ADDENDUM NO. 1

ECSUD TXDOT US HIGHWAY 87 WATER LINE RELOCATION OAK PARK ROAD TO CR 356

ADKINS, TEXAS

October 1, 2025

TABLE OF CONTENTS

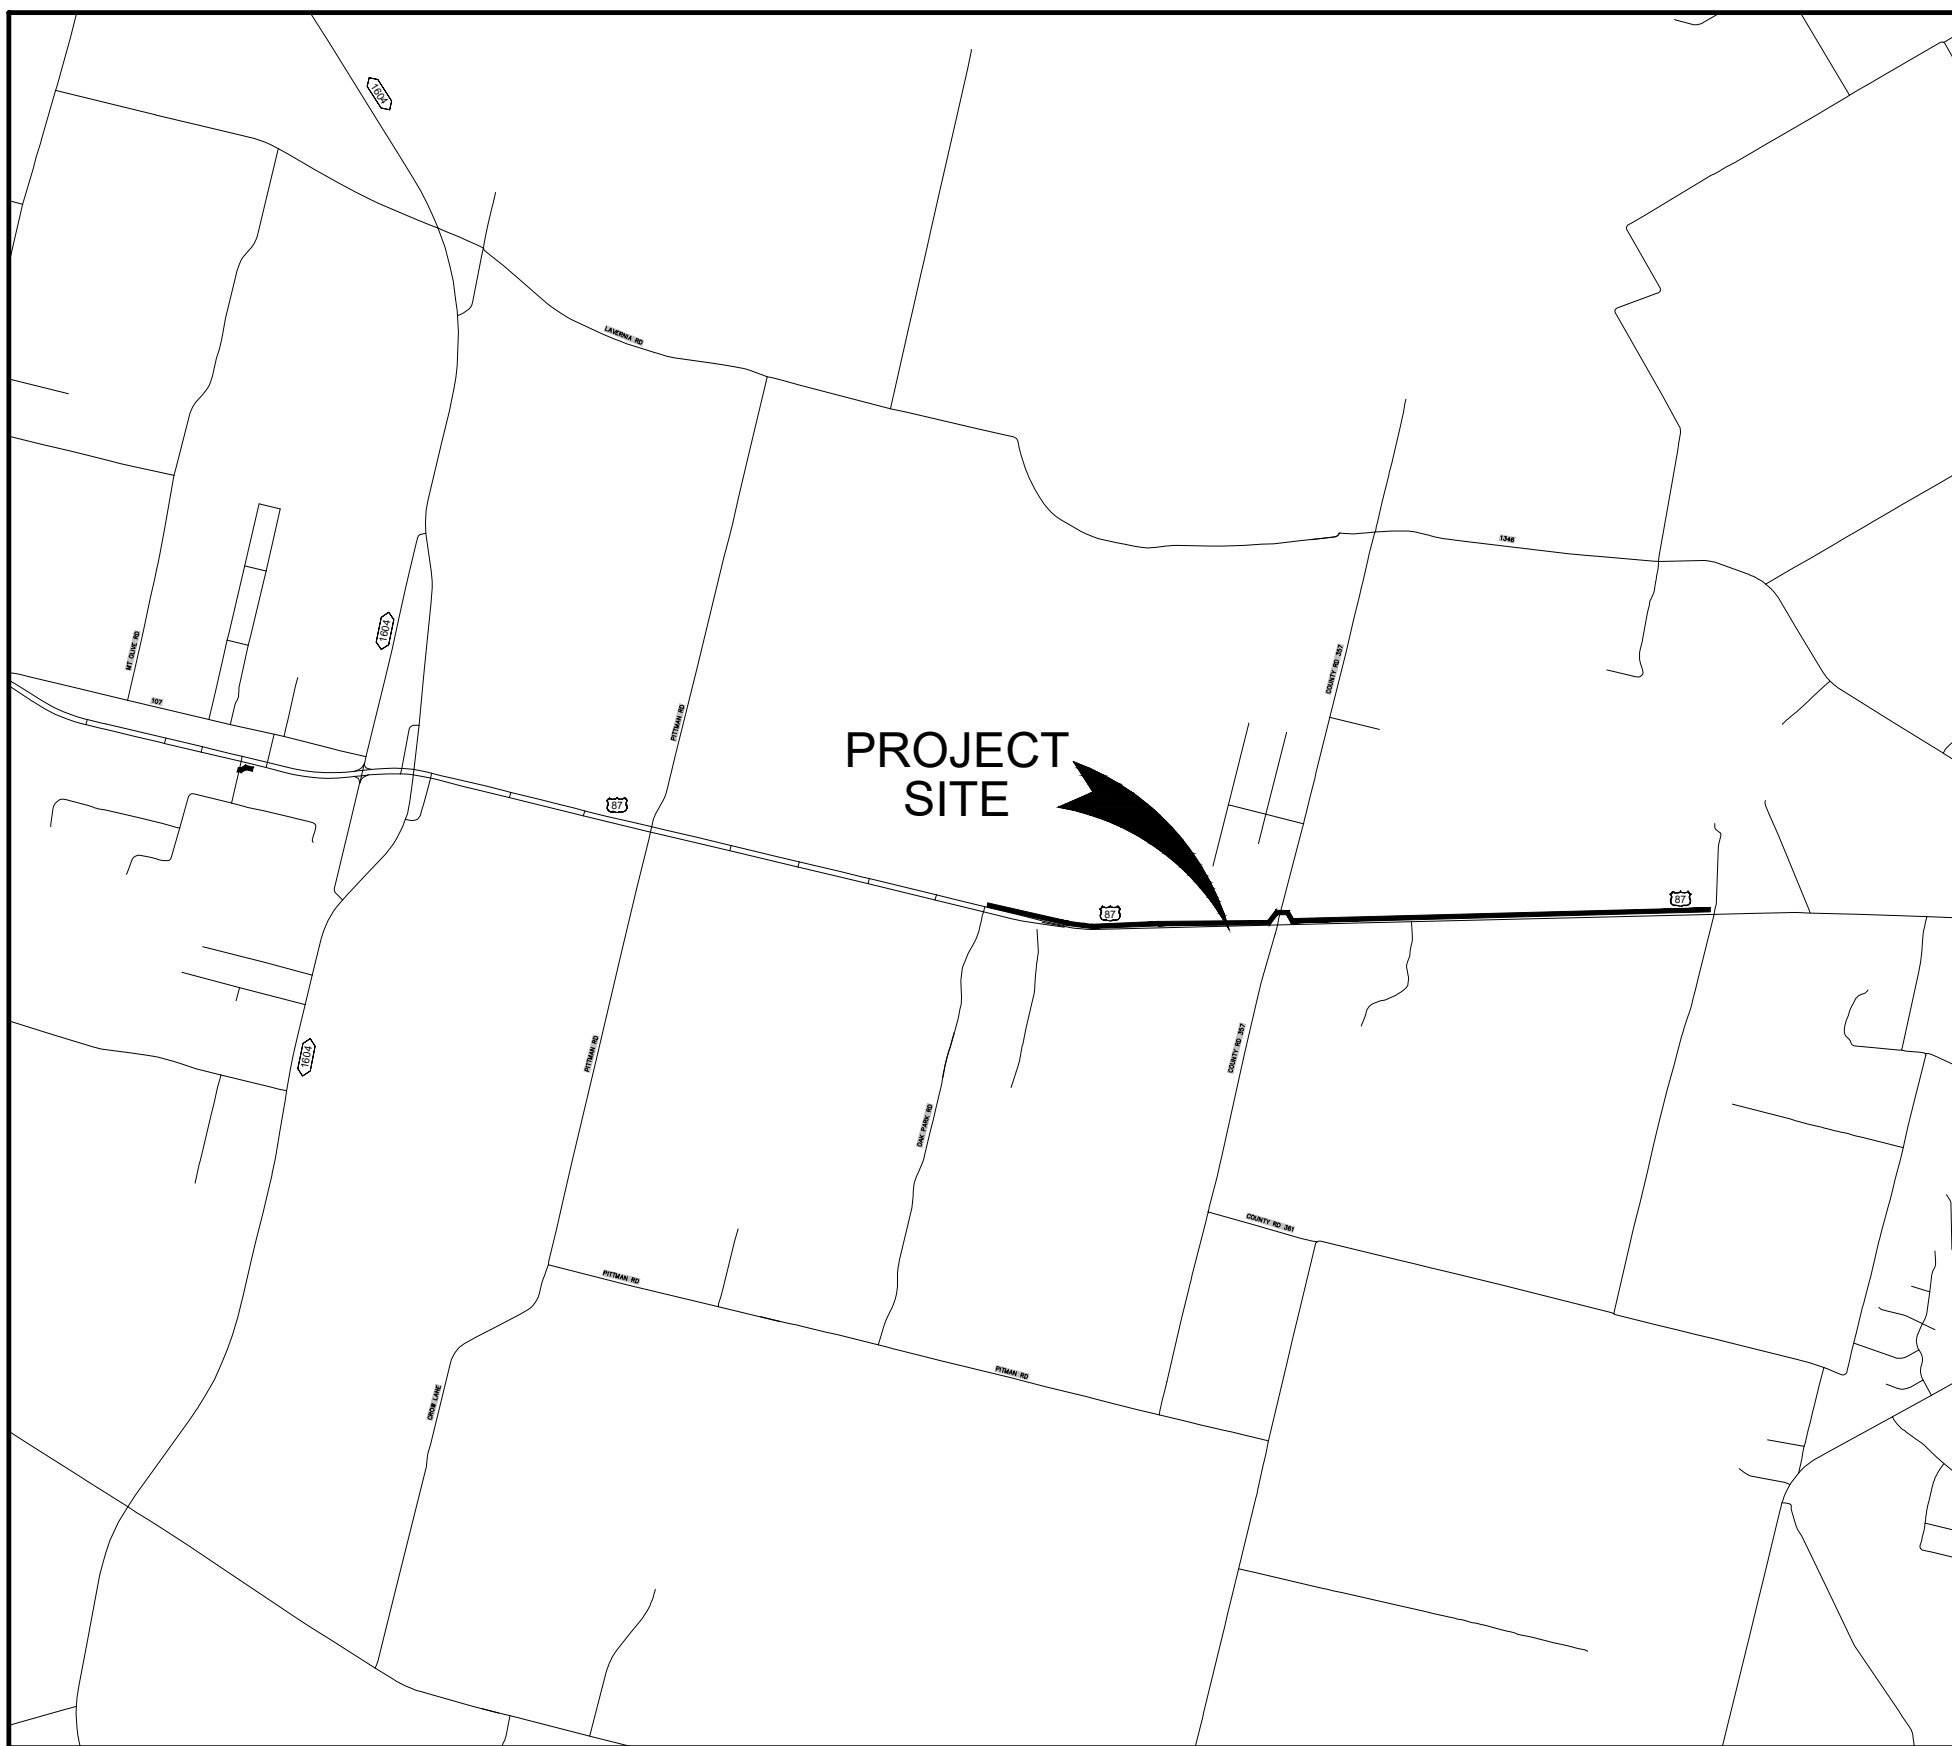
Updated quantities on the cover sheet to match Base Bid quantities, specifically the 16" steel casing via Bore is now a 20" steel casing via bore. The plan set dated September 30, 2025 on all plan sheets is considered Addendum 1 plan set and has said modification shown, attached.

ITEM	DESCRIPTION	UNIT	QUANTITY
02005	MOBILIZATION AND BOND	LS	1
02050	PREPARING THE RIGHT OF WAY	LS	1
02270	TEMPORARY SEDIMENT CONTROL FENCE	LF	815
02445.1	BORE 20" STEEL ENCASEMENT PIPE	LF	762
02445.1	BORE 24" STEEL ENCASEMENT PIPE	LF	321
02445.4	BORE HDPE DIRECTIONAL 12" I.D.	LF	566
02510.1	PVC PIPE (C909)-8", WITH SAND BEDDING & TRACER WIRE	LF	9,506
02510.1	PVC PIPE (C909)-12", WITH SAND BEDDING & TRACER WIRE	LF	5,084
02510.4	12"x4" TIE-IN	EA	2
02510.4	12"x6"x4" TIE-IN	EA	1
02511.1	REMOVAL EXISTING 4" PIPE	LF	5,700
02511.1	REMOVAL EXISTING 6" PIPE	LF	7,300
02519.1	RESTRAINED FIRE HYDRANT ASSEMBLY	EA	15
02523.1	GATE VALVE WITH BOX -4"	EA	2
02523.1	GATE VALVE WITH BOX -6"	EA	1
02523.1	GATE VALVE WITH BOX -8"	EA	24
02523.1	GATE VALVE WITH BOX -12"	EA	12
02525	DUCTILE IRON M.J. FITTINGS	TON	2.5
02540.3	RELOCATE EXISTING SERVICE, LONG (WATER METER)	EA	35
02540.3	RELOCATE EXISTING SERVICE, SHORT (WATER METER)	EA	10
